## Access Compliance Report Public Rights-of-Way (Curb Ramps)

Intersection ID: 14540Main Street:BRIAR\_CREEK\_RDCross Street:E\_INDEPENDENCE\_BVLocation:WADA ID: C6ECE51B79DCRamp Type:IslandPerpInitial Pass/Fail:FailOverall Compliance:NoSeverity Score:21.25

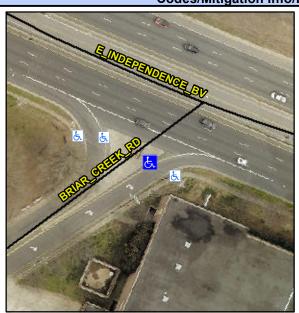
Not Found, R304.5.1, R304.2.2

Field Measurements/Component Compilance					
Compliance Description		Data	Compliance Description		Data
N/A	Ramp Length (in)	59.0	No	Ramp Slope (%)	10.2
No	Ramp Width (in)	43.0	Yes	Ramp XSlope (%)	1.9
N/A	Flare Type LT	N/A	N/A	Flare Type RT	N/A
N/A	Flare Slope LT (%)	N/A	N/A	Flare Slope RT (%)	N/A
N/A	Flare Traversable LT?	N/A	N/A	Flare Traversable RT?	N/A
N/A	Landing Length (in)	N/A	N/A	DWS Provided?	N/A
N/A	Landing Width (in)	N/A	N/A	DWS Contrast?	N/A
N/A	Landing Slope (%)	N/A	N/A	DWS Length (in)	N/A
N/A	Landing X Slope (%)	N/A	N/A	DWS Full Width?	N/A
N/A	Landing Curb? (Y/N)	N/A	N/A	DWS Offset (in)	N/A
N/A	Shared Landing?	N/A			
N/A	Gutter Ponding?	N/A	N/A	Gutter Slope (%)	N/A
N/A	Gutter Lip Ht (in)	N/A	N/A	Gutter X Slope (%)	N/A
N/A	Painted X Walk1?	No	N/A	Painted X Walk2?	N/A
	X Walk 1 Direction	To SE		X Walk 2 Direction	N/A
N/A	X Walk 1 Width (in)	N/A	N/A	X Walk 2 Width (in)	N/A
	X Walk 1 Slope (%)	0.6		X Walk 2 Slope (%)	N/A

Remove & Replace Entire Ramp.
